**Harker Heights
Planning and Zoning
Commission
Meeting & Workshop**

1. **P21-14** Discuss and consider a request for Preliminary Plat approval for the subdivision referred to as The Village at Nolan Heights, on property described as a 47.65 acre tract of land in Bell County, Texas, being part of the H.B. Littlefield Survey, Abstract No. 511, and being all of the called 47.626 acre tract of land described in a deed to Cactus Jack Development, Inc., recorded in Instrument No. 2020-064289, Deed Records of Bell County, Texas, generally located North of KISD Middle School No. 14, AKA Nolan Middle School along Warriors Path, Harker Heights, Bell County, Texas.

PLANNING AND ZONING COMMISSION MEMORANDUM

Below is the response to comments for The Village at Nolan Heights Preliminary Plat, received on April 7, 2021. Response to comment is in **bold**.

**PRELIMINARY PLAT FOR:
THE VILLAGE AT NOLAN HEIGHTS
CITY OF HARKER HEIGHTS, BELL COUNTY, TEXAS**

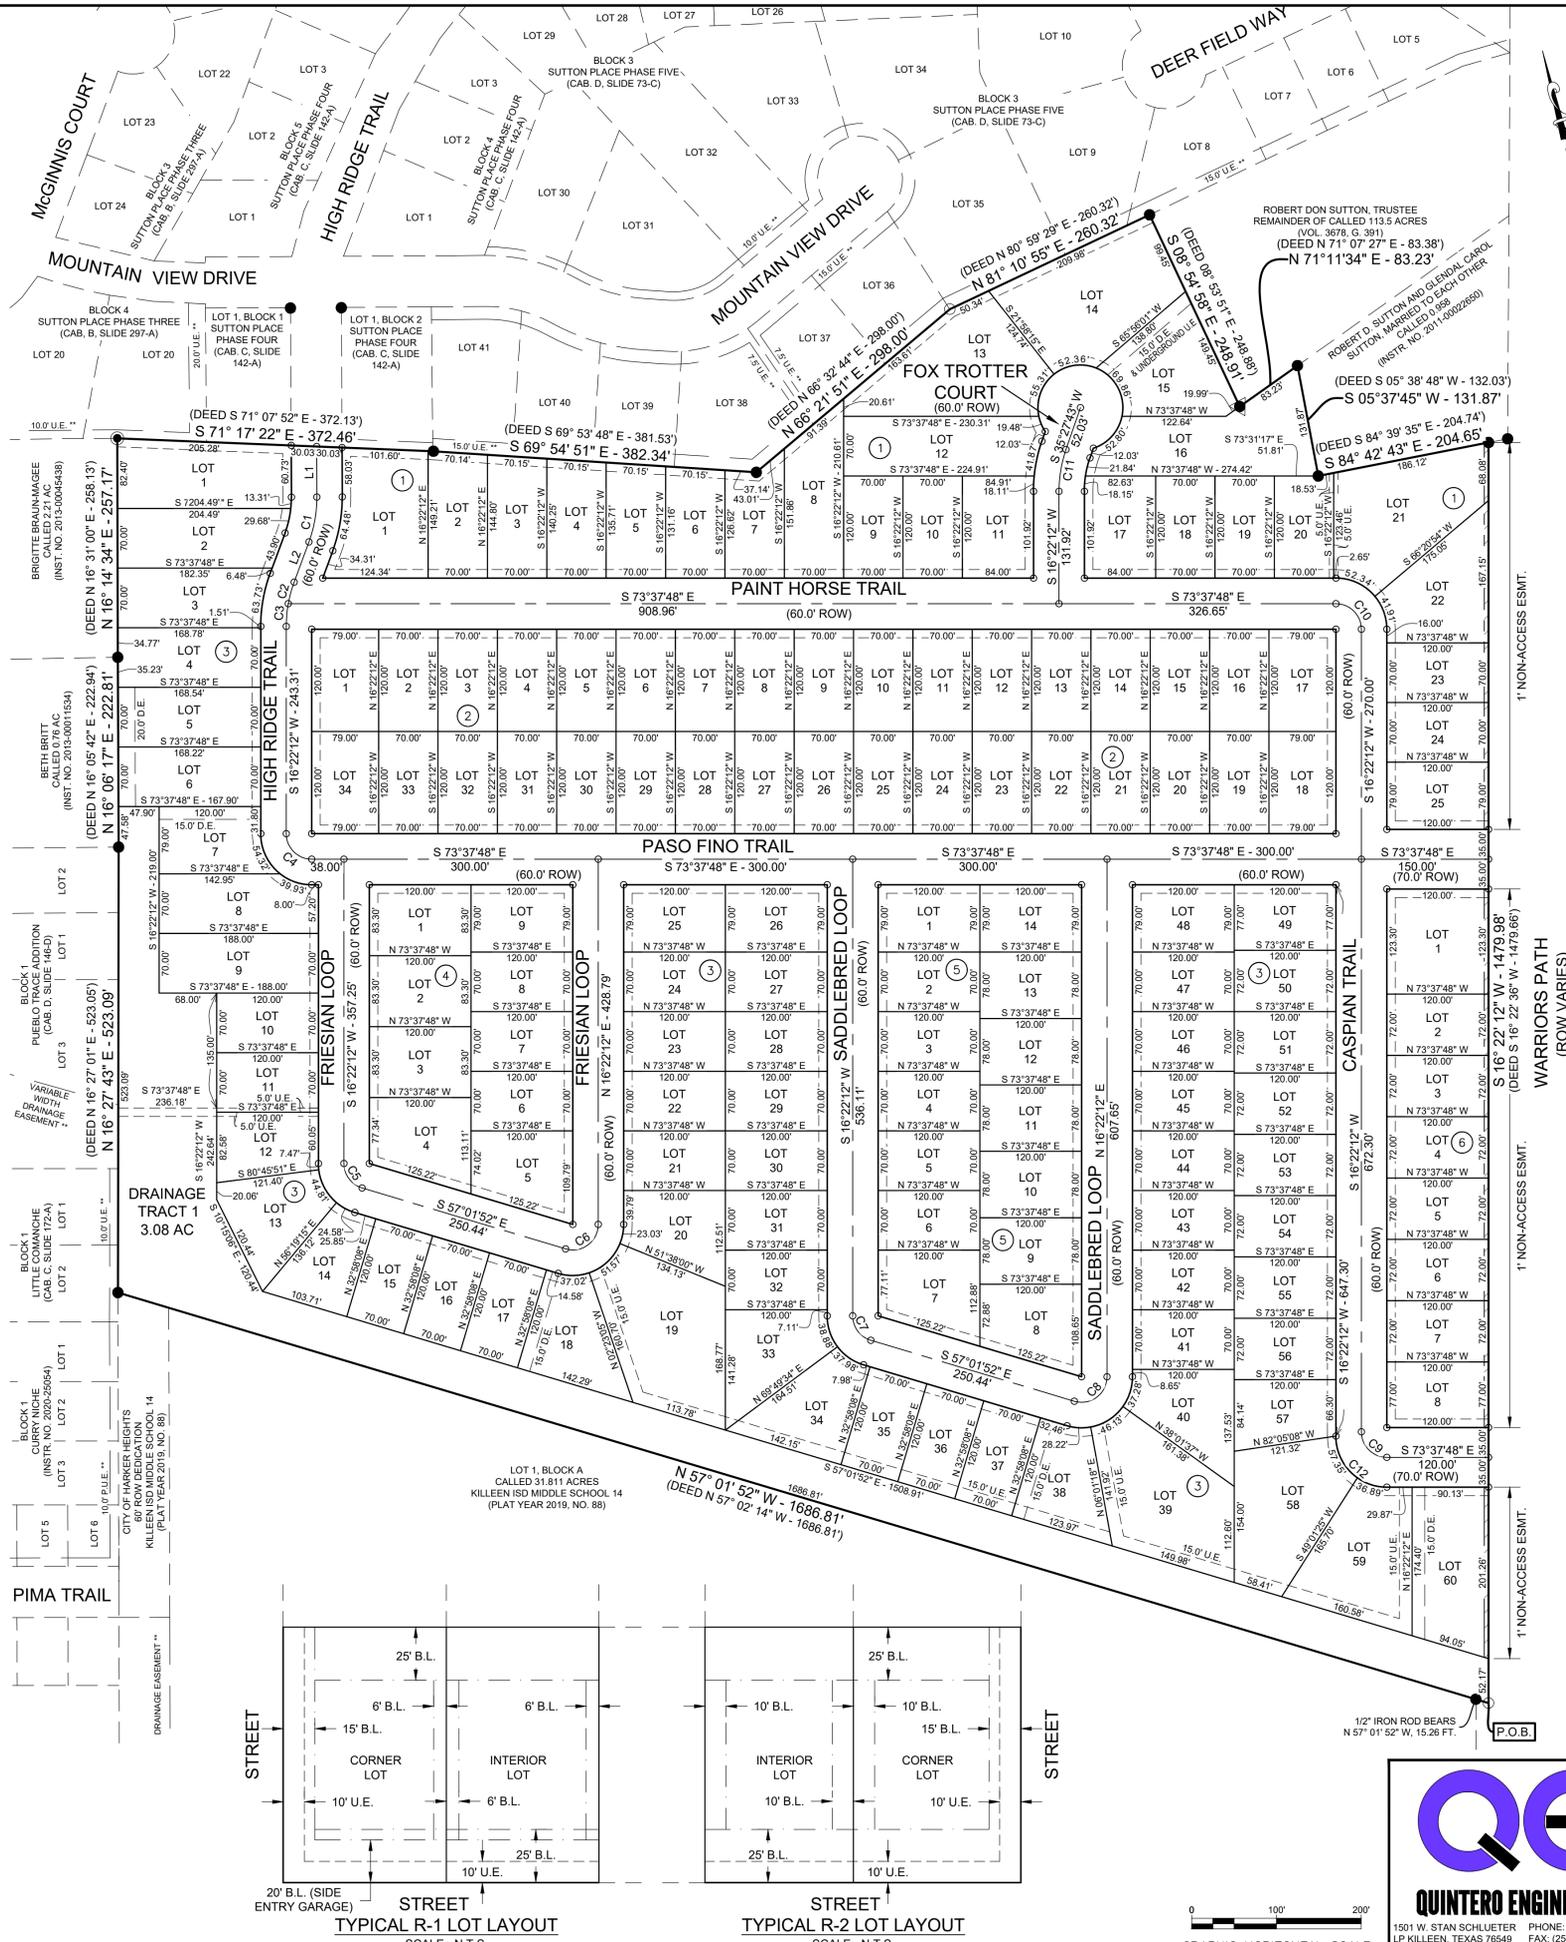
2. Plat – Provide a Plat Note stating which block/lots will be developed as R-1 – Single Family and those that will be developed at R-2 – Duplex.
Note has been added (note 10).

3. Plat – Please show setbacks for lots.
 - a. R-1 – Front: 25’ (20’ for side entry garages), Side: 6’ and 15’ when adjacent to a side street, Rear: 20’

4. Plat – Plat Note #7 states that “homes built on lots that front two streets shall be built with the front of the house facing the street upon with the lot has smaller linear frontage”. In the case of Block 6, Lot 1 I presume this will be a duplex and would like to suggest that this dwelling not front Paso Fino Trail at the beginning of the subdivision.
Correct, the intention is for that lot’s structure to face Caspian Trail. Note 7 has been revised to insure lot 1, block 6 faces Caspian Trail.

5. KR- Plat Dedication Page Note 1 shall be amended to apply to all parcels within the subdivision not just a single tract.
Note has been revised to refer to the whole development.

6. KR- Please verify spelling in Note 2 in the plat dedication page.
Note has been updated.
7. KR- Plat Dedication Page Note 3 shall be amended to also include FEMA Map 48027C0295E, which effects the southeast corner of the development.
Note has been updated.

8. KR- Plat Dedication Page Note 3 shall be amended to include an exception statement for Lots 1-9 Block 6, Lot 60 Block 3, and Lots 21-25 Block 1 such that said lots shall not have access to Warrior's Path. Per Section 154.37, applicant shall place a 1-foot non-access easement along Warrior's Path.
I believe this comment is meant for Note 7. Note 9 was revised to include the exception statement for access for lots adjoining Warriors Path and the non-access easement has been added.

9. KR- Due to changes beyond the city's control, Note 9 be removed from the plat dedication page. The sidewalks will be required to be installed at the time of development.
Note 9 has been removed. Sidewalks along Warriors Path have been added to the sidewalk layout.

10. KR- Per Section 154.42 of the code of ordinances, provide a utility easement (for sewer) near or on Lots 11 and 12, Block 3 such that it provides connectivity across Drainage Tract 1 and the existing offsite western drainage tract onto Pueblo Trace.
A 10' U.E. along the common lot line of lots 11 and 12, block 3 and the drainage tract has been added.

11. KR- Per Section 154.42 of the code of ordinances, provide a utility easement (for sewer) to the offsite parcels adjacent to the northeast corner of this subdivision.
The 15' Drainage Easement along Lot 15, Block 1 has been revised to also be an underground Utility Easement. A 10' U.E. along the common lot line of Lots 20 & 21, Block 1 has been added, please see revised plat.

- b. R-2 – Front: 25’, Side: 10’ or 15’ when adjacent to a side street, Rear: 20’
A typical lot layout has been added. Setback on each individual lot cluttered the plat making it almost illegible.

THIS DOCUMENT IS RELEASED FOR THE PURPOSE OF REVIEW UNDER THE AUTHORITY OF JOSEPH THERIOT, P.E. 120299 ON 4/12/2021. IT IS NOT TO BE USED FOR CONSTRUCTION, BIDDING, OR PERMIT PURPOSES.	DESIGN	JAT
	DRAWN	JAT
	CHECKED	JAT
	PROJECT #	20-010-001
	DRAWING #	9

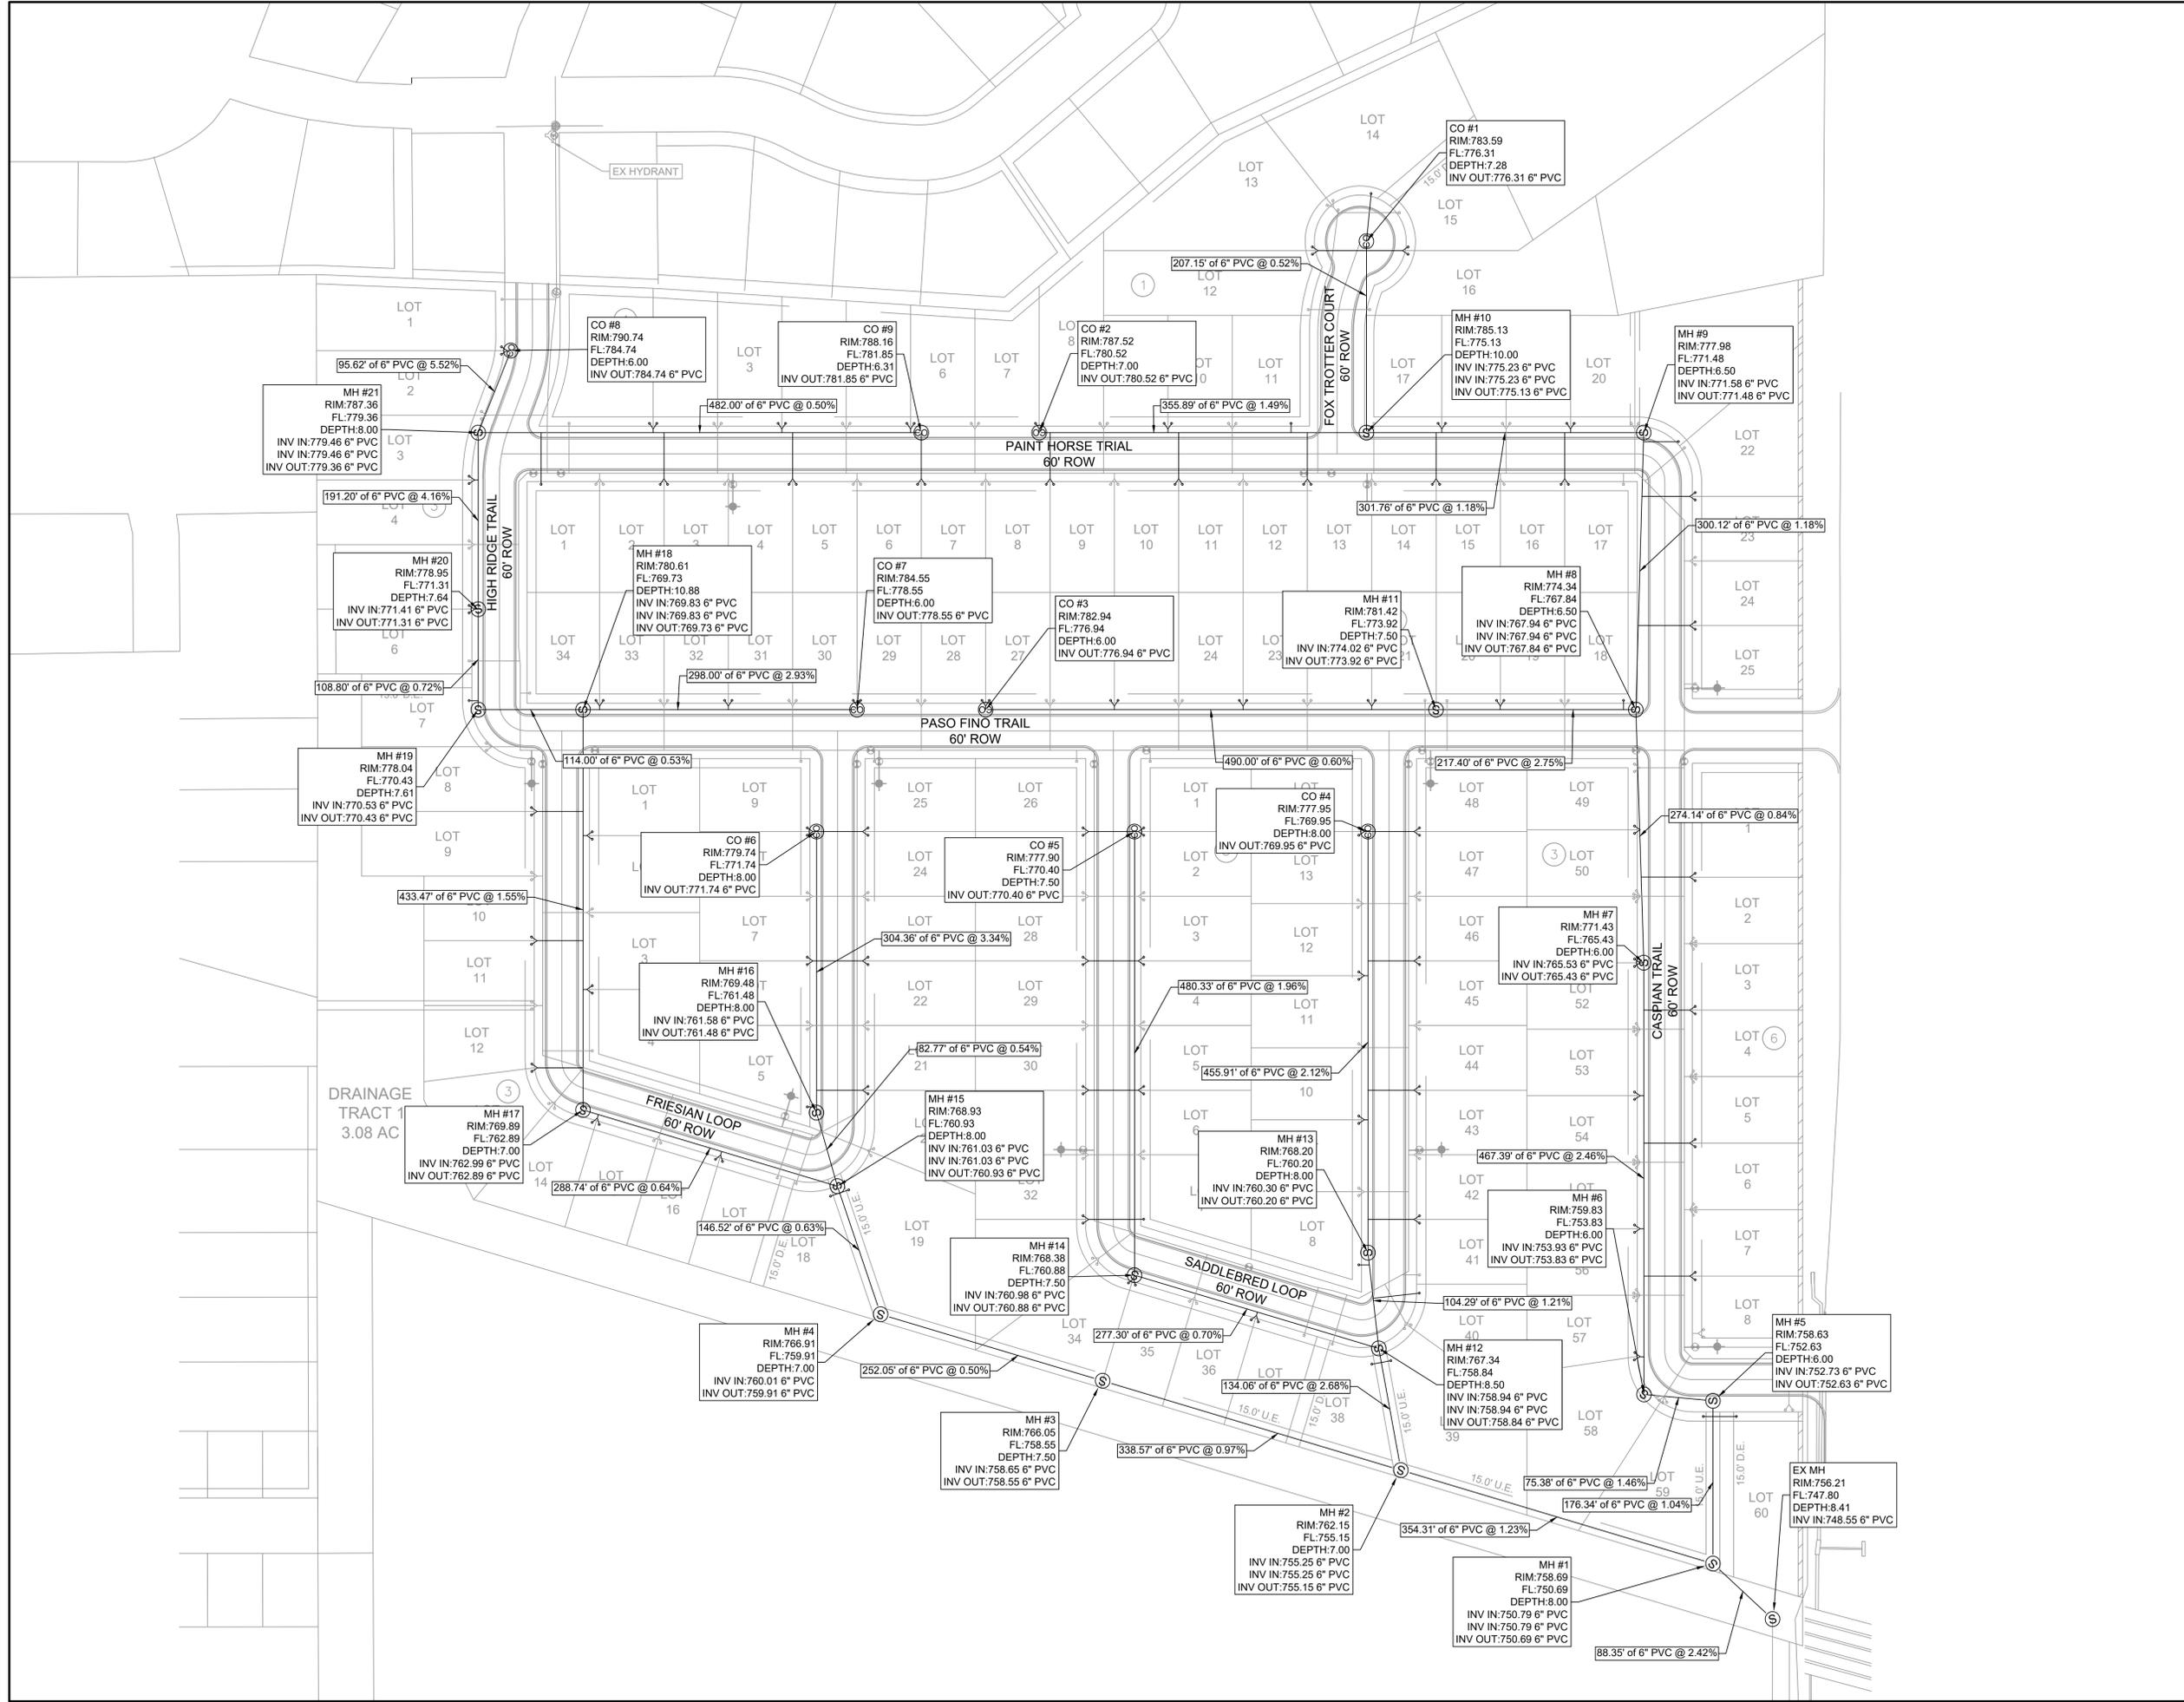
13. KR- On Sheet 9 add a note that manholes within or immediately adjacent to drainage easement shall have a watertight ring and cover.

Note has been added.
